SB, CRT Kubota engines exhaust system correct torque values, CRT 48-33K, CRT 48-57K, 2024-01

Fig. 1: Torque values for 33K models equipped with WG 972 engine.

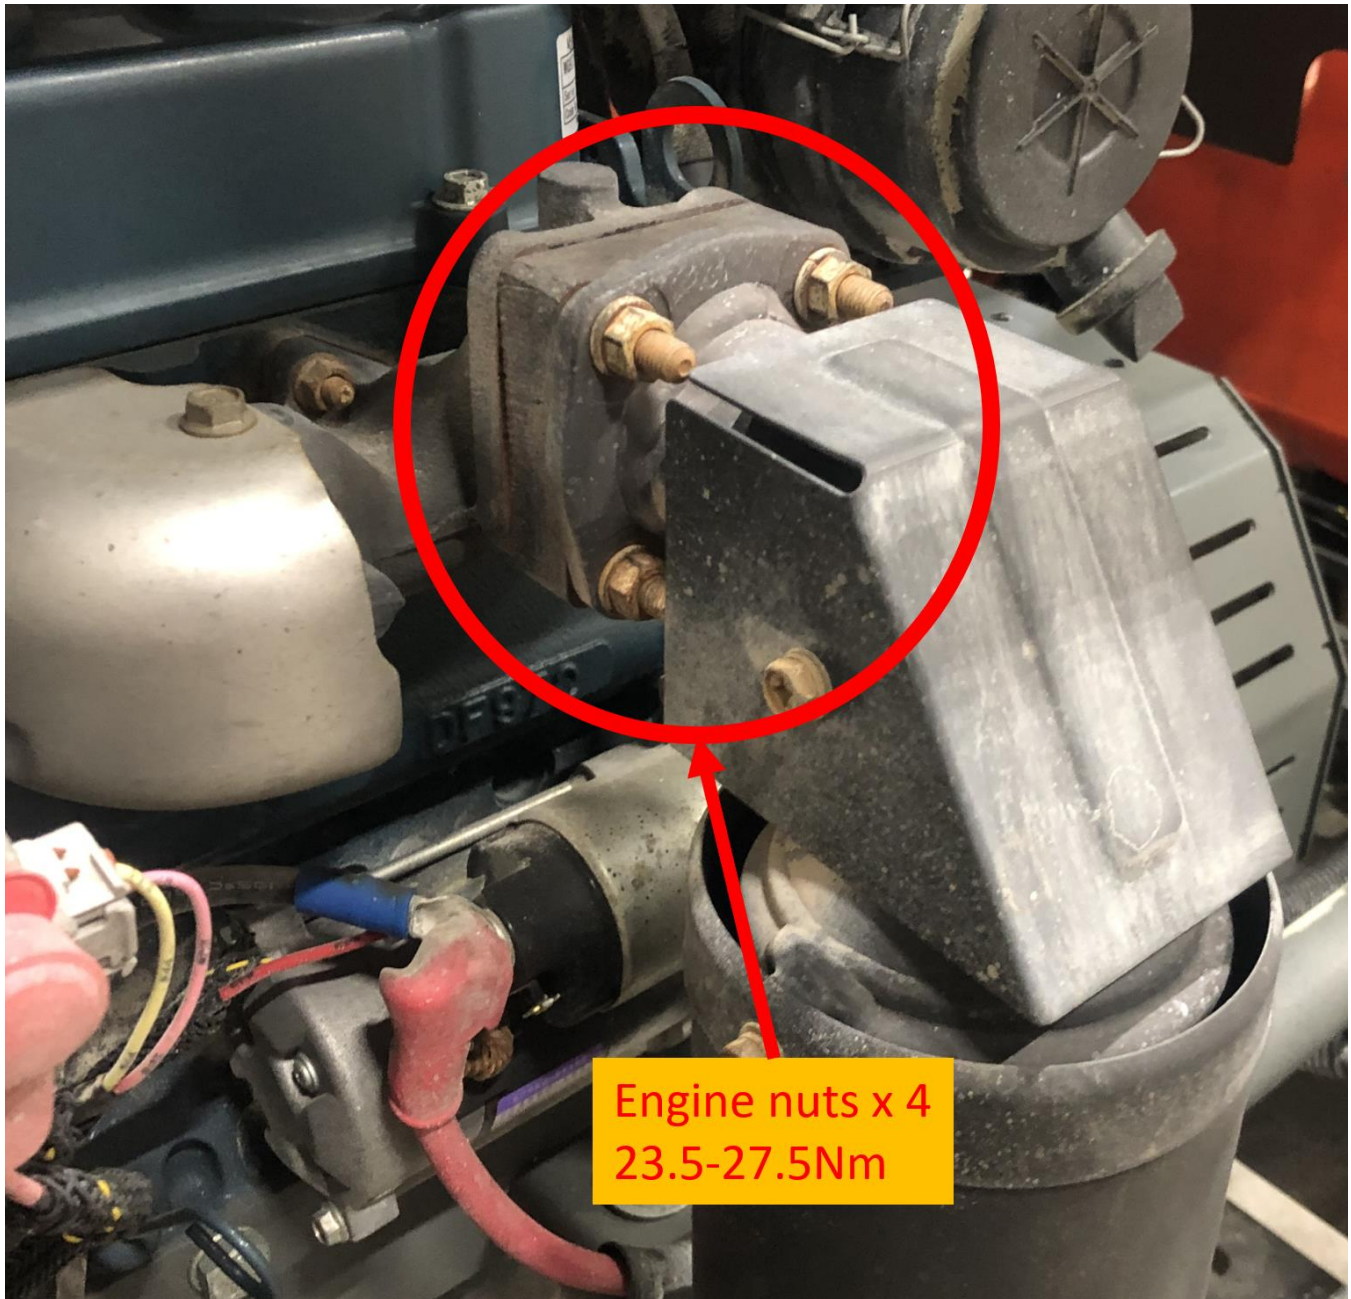
Due to incorrect torque values on the exhaust system, a leakage could occur which causes the engine to fall out of emission specification.

Check and if needed, correct the torques according to below instructions.
